# Access Compliance Report

## Public Rights-of-Way

### (Curb Ramps)

Intersection ID: 11269	Main Street: GRANGER_AV	Cross Street: KEMPTON_PL	Location: S
ADA ID: 35E3118A1C78	Ramp Type: Perp	Initial Pass/Fail: Fail	Overall Compliance: No
		Severity Score: 1.25

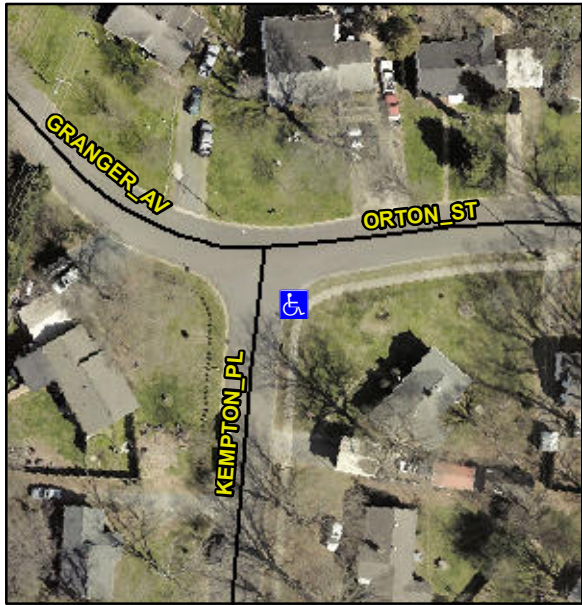
Codes/Mitigation Info/Possible Solution			Field Measurements/Component Compliance					
	Possible Solutions:		Compliance	Description	Data	Compliance	Description	Data
	Remove & Replace Entire Ramp.		N/A	Ramp Length (in)	48.0	Yes	Ramp Slope (%)	7.9
			Yes	Ramp Width (in)	48.0	No	Ramp XSlope (%)	3.4
			N/A	Flare Type LT	N/A	N/A	Flare Type RT	N/A
			N/A	Flare Slope LT (%)	N/A	N/A	Flare Slope RT (%)	N/A
			N/A	Flare Traversable LT?	N/A	N/A	Flare Traversable RT?	N/A
			N/A	Landing Length (in)	N/A	N/A	DWS Provided?	N/A
			N/A	Landing Width (in)	N/A	N/A	DWS Contrast?	N/A
			N/A	Landing Slope (%)	N/A	N/A	DWS Length (in)	N/A
			N/A	Landing X Slope (%)	N/A	N/A	DWS Full Width?	N/A
Surveyor Notes:		N/A	N/A	Landing Curb? (Y/N)	N/A	N/A	DWS Offset (in)	N/A
PROW/ADA:		Not Found, R304.5.3	N/A	Shared Landing?	N/A			
			N/A	Gutter Ponding?	N/A	N/A	Gutter Slope (%)	N/A
			N/A	Gutter Lip Ht (in)	N/A	N/A	Gutter X Slope (%)	N/A

N/A	Painted X Walk1?	No	N/A	Painted X Walk2?	N/A
				X Walk 1 Direction	To W		X Walk 2 Direction	N/A
			N/A	X Walk 1 Width (in)	N/A	N/A	X Walk 2 Width (in)	N/A
				X Walk 1 Slope (%)	2.6		X Walk 2 Slope (%)	N/A
				X Walk 1 X Slope (%)	6.1		X Walk 2 X Slope (%)	N/A
			N/A	Ramp inside XWalk1?	N/A	N/A	Ramp inside XWalk2?	N/A
				Road Slope (%)	6.1	N/A	Clear Space?	N/A
				Road X Slope (%)	2.6	N/A	Clear Space to XWalk (in)	N/A
			N/A	Any Obstructions?	N/A	N/A	Storm Grate/Utility Hazard?	N/A
				Obstruction Type			Storm Grate/Utility Type	
					N/A			N/A
						Yes	Surface Condition? (G/P)	Good
Street 1 Name		KEMPTON PL						
Stop Condition-Street 2		StopSign						
Street 2 Name		N/A						
Stop Condition-Street 1		N/A						
Total Cost:		\$ 1850.00
